**AMMANA MARKET RENOVATION
MAJJASIM, IRAQ**

SUSTAINMENT ASSESSMENT

**SIGIR PA-09-171
JULY 30, 2009**

SUBJECT: Report on Sustainment Assessment of the Ammana Market Renovation, Majjasim, Iraq (SIGIR Project Number PA-09-171)

Figure 1. General site plan for the market

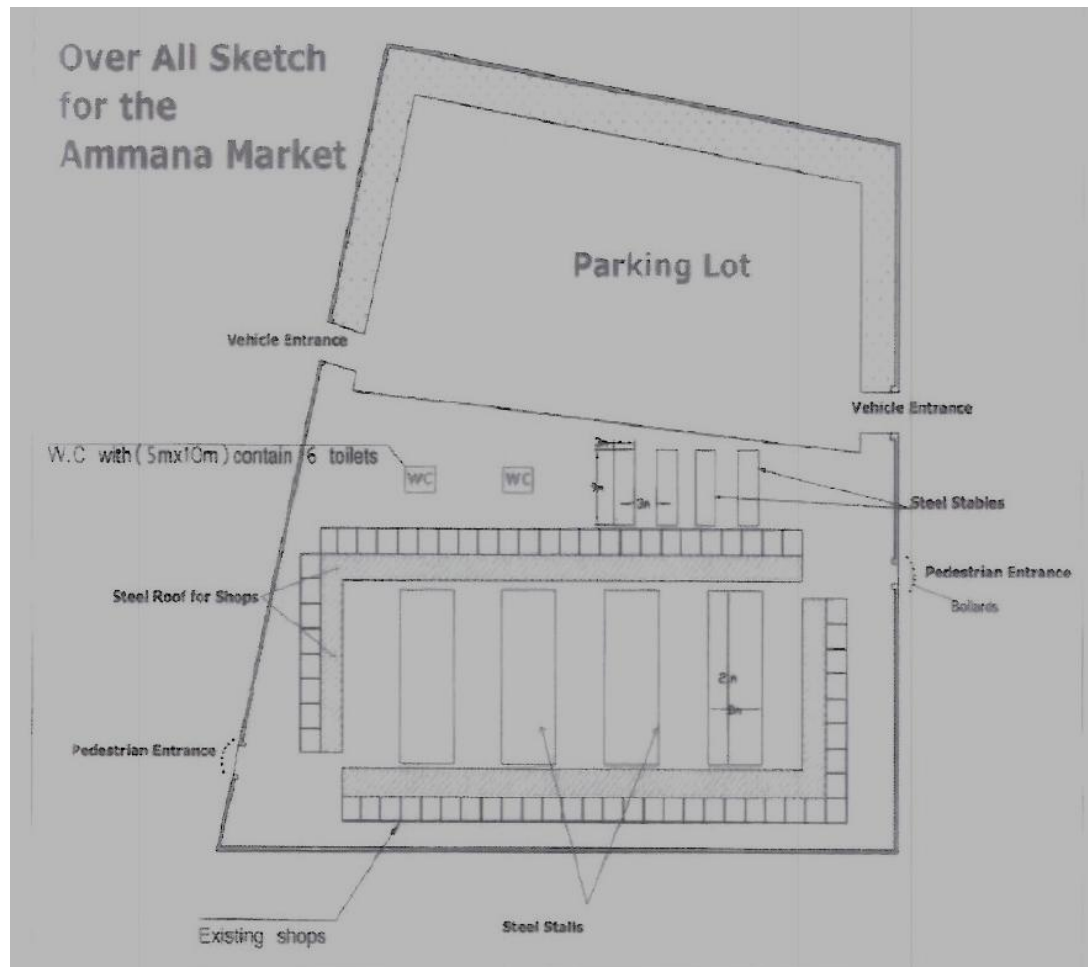
After reviewing the available project file documentation, SIGIR determined that adequate information was provided in the specifications for the contractor to complete the final design and construct the Ammana Market.
